Service Bulletin

Machinery Affected: Horizontal Stacker
Document: SB208-D rev. A
Title: Replacing the PLC and Touch Screen Monitor
Applies To: All PLCs Prior to RX3i
Distribution: Customers Upon Order

Part # and Rev.	SB208-D rev. A
Revision Date	29 Sept. 2016
Revised By	G. Gaia
Approved By	V. Carroll
Print Date	30 September 2016
Orig Date Created	16 Sept. 2016
Created By	G. Gaia
Applicability	Prior to 90436i

Figure 11: Slots and Components on New Backplane

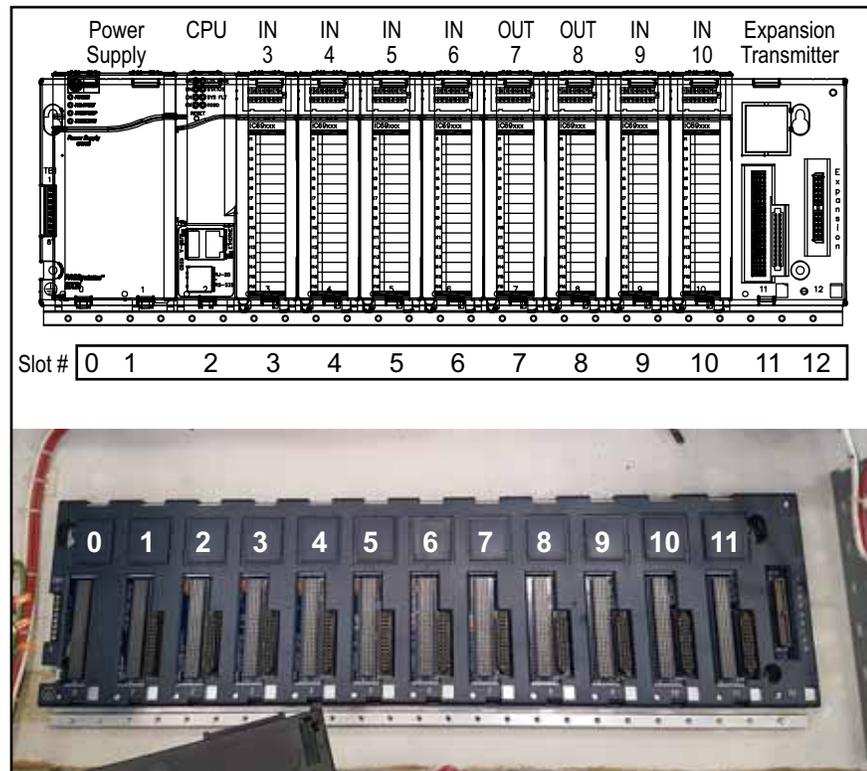
1. Place PLC components onto the new backplane by using the following steps and referring to Figure 11.

- a) Place the new power supply in slots #0 and #1.
- b) Check the rear of the CPU. If a yellow tab is attached to the CPU, pull it free carefully without removing the battery. See Figure 12. Place the CPU into slot #2.

- d) Reconnect the red, white, and green wires to the power supply.
- e) Snap the yellow Ethernet cable into the CPU as shown in Figure 14. The cable will not connect at its other end yet.
- f) Place the input and output modules back on the backplane. Refer to Figure 11.
 - 1) Install module #1 in slot #3.
 - 2) Install module #2 in slot #4.
 - 3) Continue until all modules are installed on the backplane. The backplane is now reassembled.
- g) See Figure 15 to confirm that the backplane is properly assembled.

Figure 13: Connecting the Energy Pack With the CPU

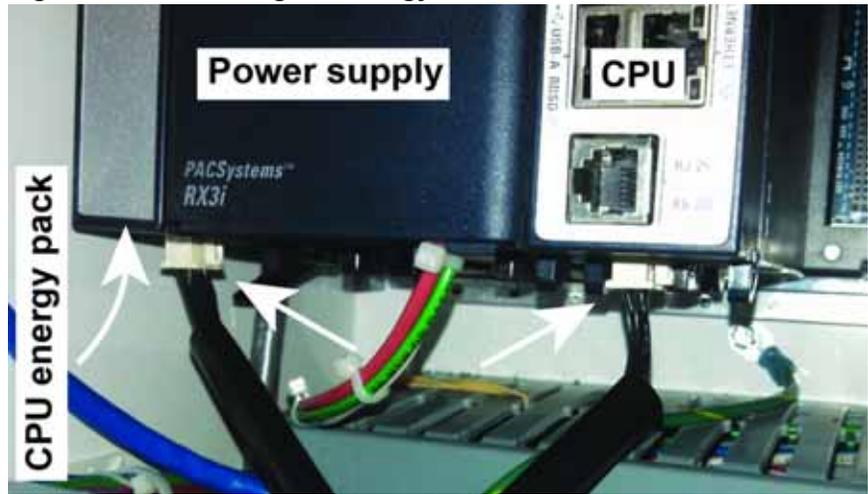
- c) Attach the energy pack to the left-hand side power supply, and connect the energy pack to the CPU using the black cable with white connectors. These connectors snap into the bottom of the energy pack and the CPU as shown in Figure 13. The energy pack does not connect directly to the backplane.

Figure 16: Shifting the Circuit Breakers

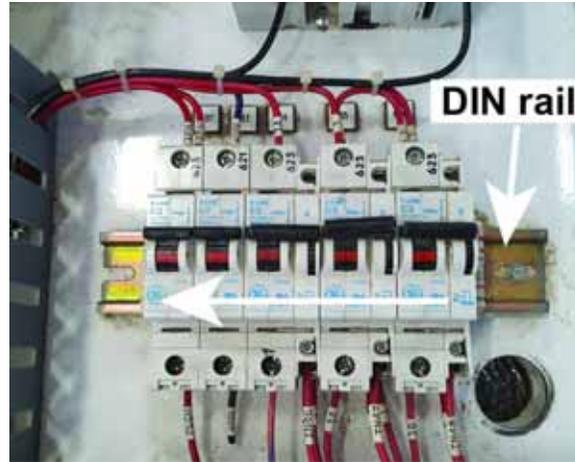
1. Locate the circuit breakers on the DIN rail to the right of the backplane as shown in Figure 16. Slide all of the circuit breakers to the left. This should leave more space on the DIN rail to the right of the breakers.

Figure 17: Mounting 24V Power Supply

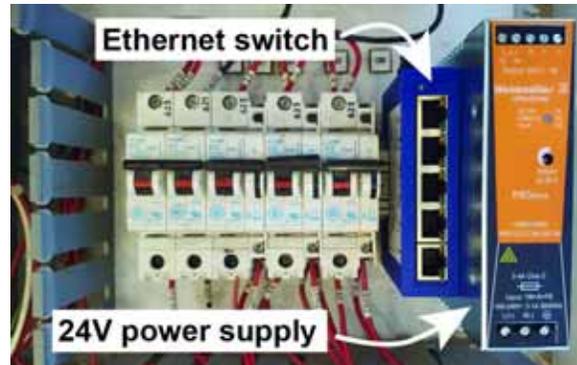
2. Mount the Ethernet switch on the DIN rail to the right of the circuit breakers. Mount the 24V power supply to the right of the Ethernet switch, as shown in Figure 17.

Figure 18: Wiring the 24V Power Supply

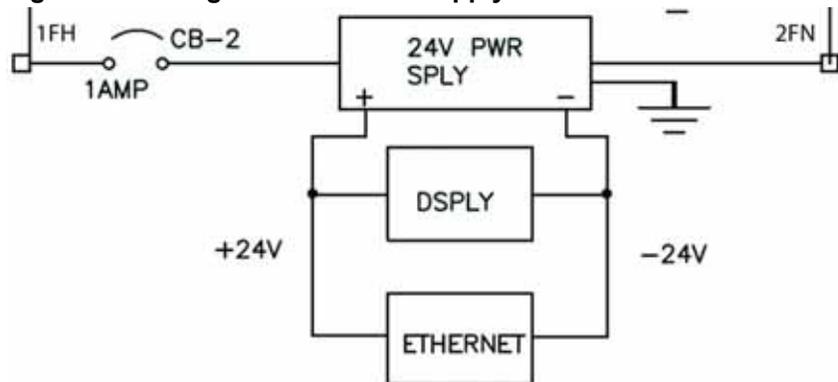
3. Connect wires and cables to the 24V power supply and Ethernet switch using the following directions.
 - a) Loosen the screws on the second circuit breaker from the left (it is the only 1-amp circuit breaker on the DIN rail). Remove the blue wires from the second circuit breaker. Replace them with red 16-gauge wire. See Figure 18.
